**City of Bellevue  
Development Services Department  
Land Use Staff Report**

**Proposal Name:** Dawson Lane Short Plat

**File Number:** 13-135823-LN

**Director's Decision:** Approval with Conditions

**CLEARING, GRADING & ROAD PLAN**

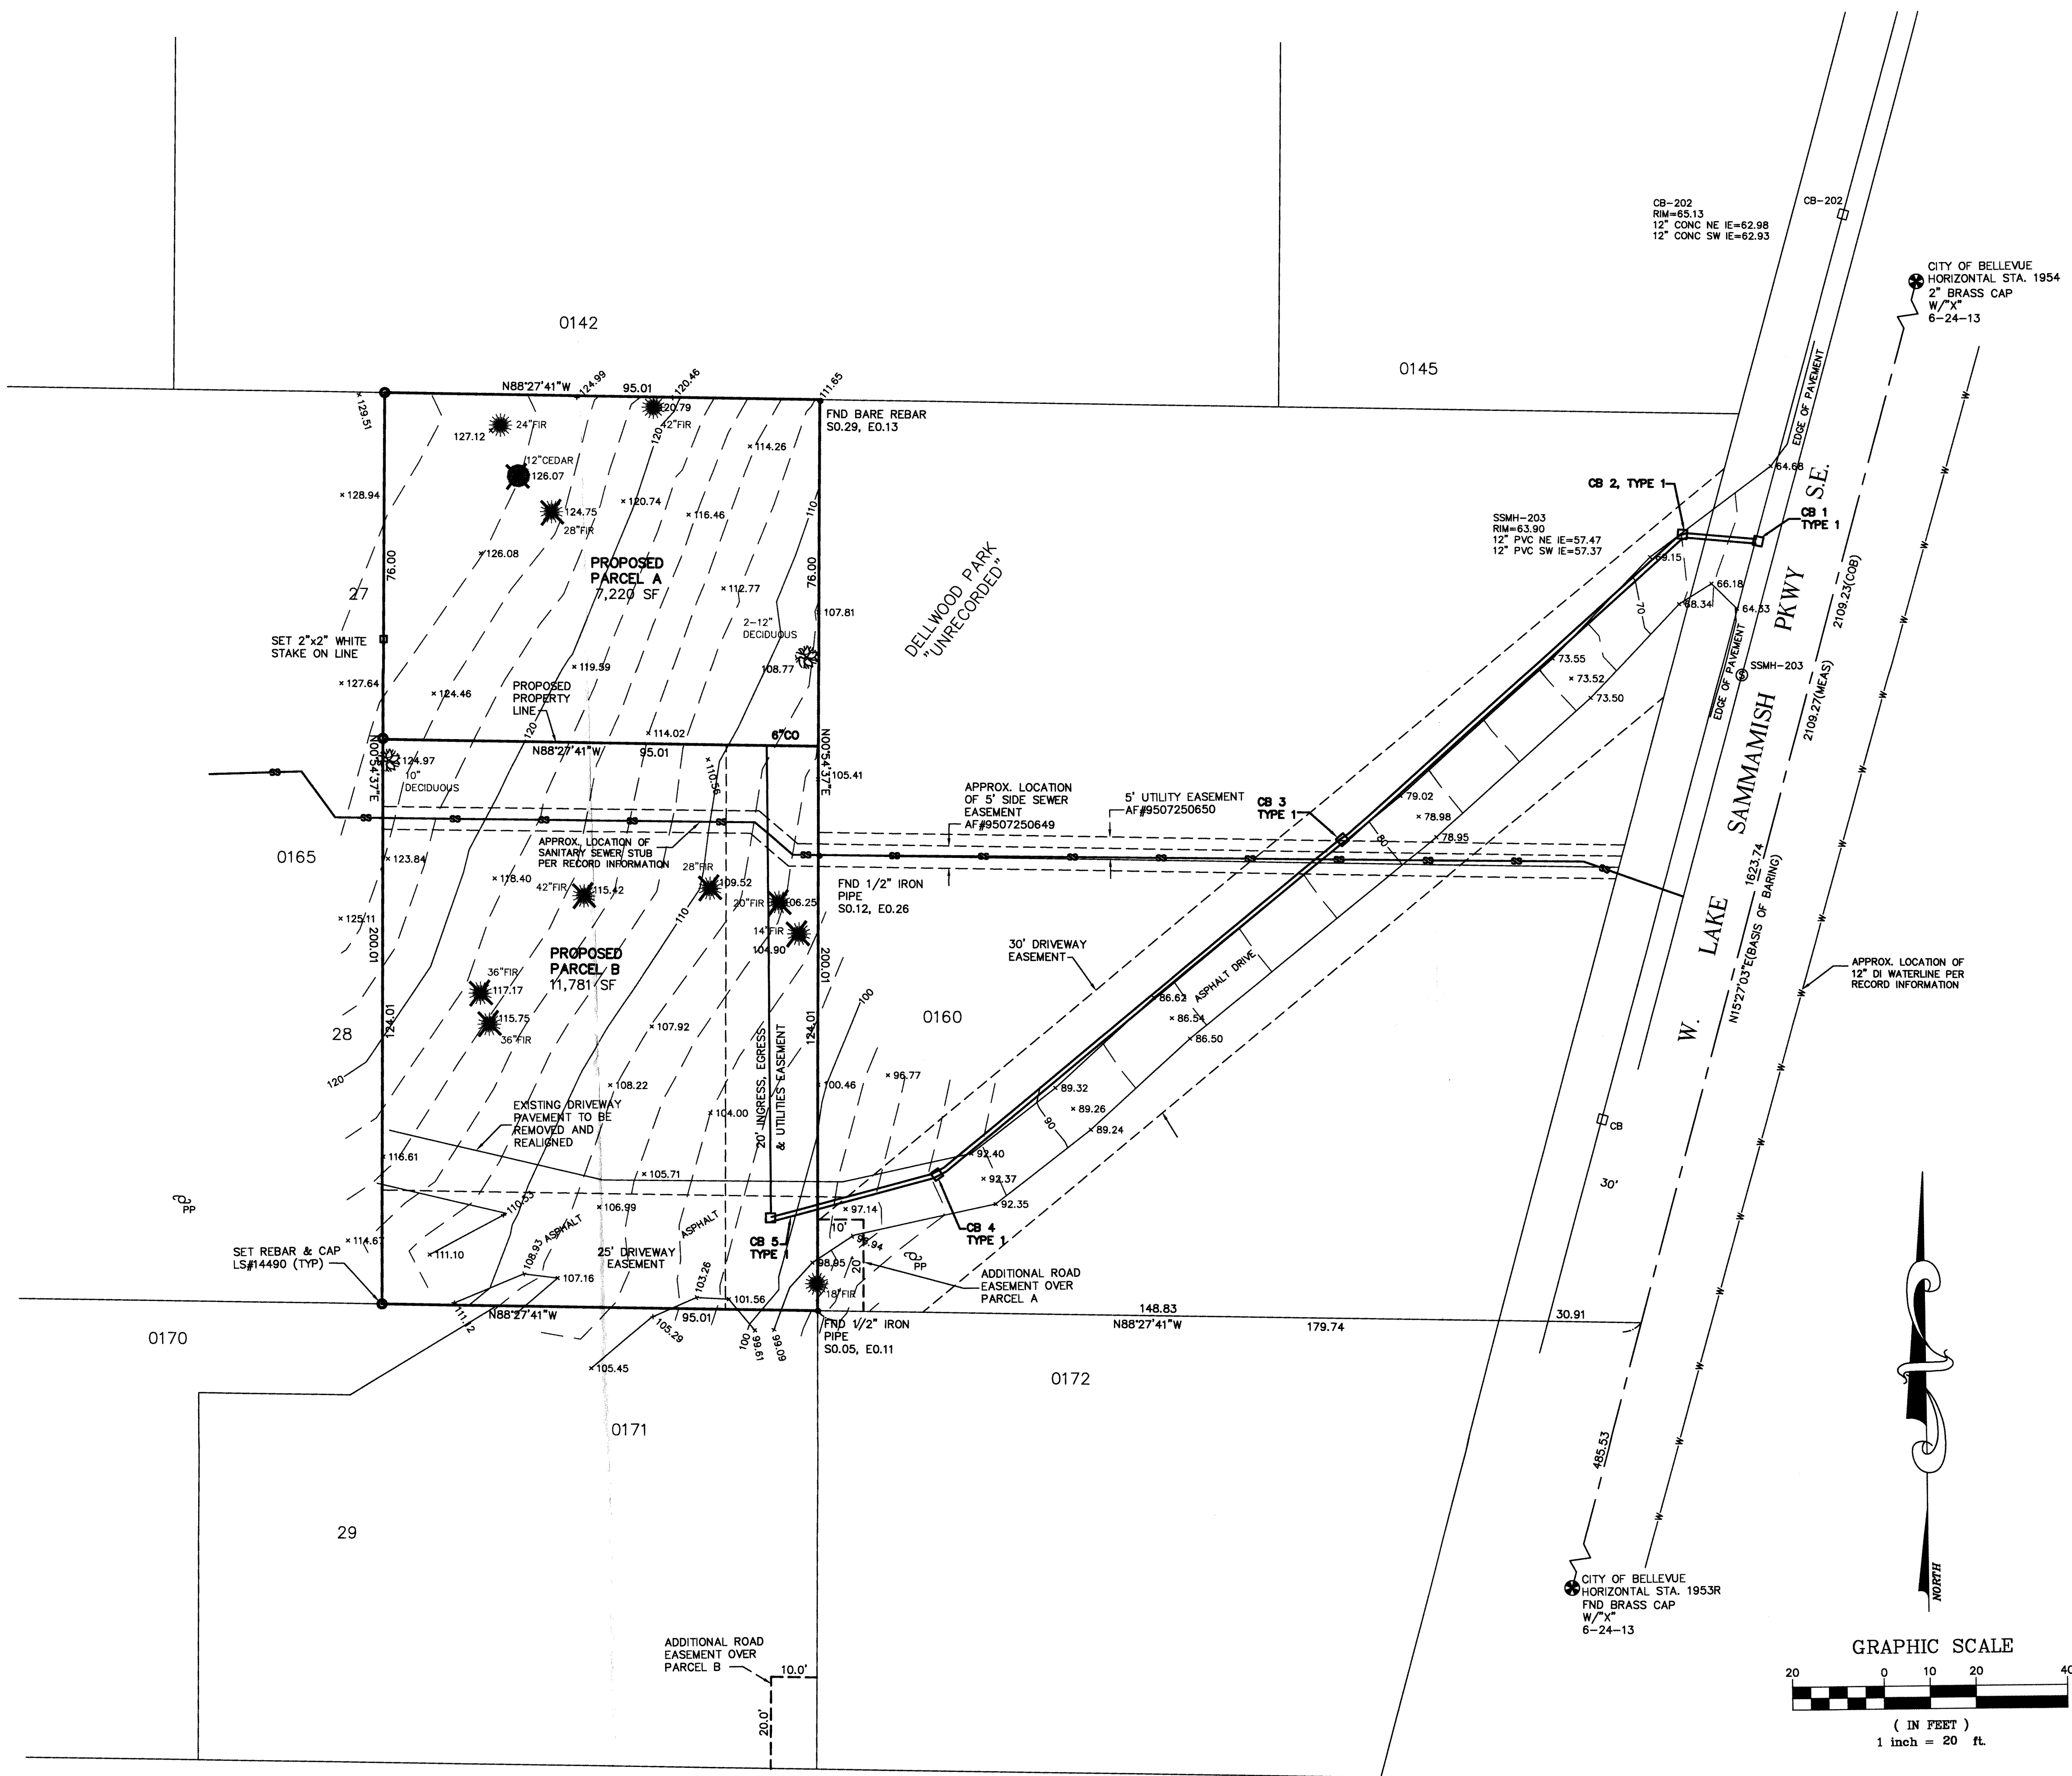
*The plans show the easement for the driveway incorrectly.*

*A private agreement for an additional five feet on the north side of the 20-foot access easement has been agreed upon. The plan does not show this agreement.*

An updated copy of the 25 and 30-foot shared access easement has been received and the plans reflect the privately agreed boundaries of these easements.

The applicant has provided an updated plan that depicts a 25-foot easement along the southerly boundary of Parcel B, and has updated the Clearing, Grading, and Road plan to include a relocation of the existing drive in accordance with a private agreement between the property owner directly to the west and the applicant.
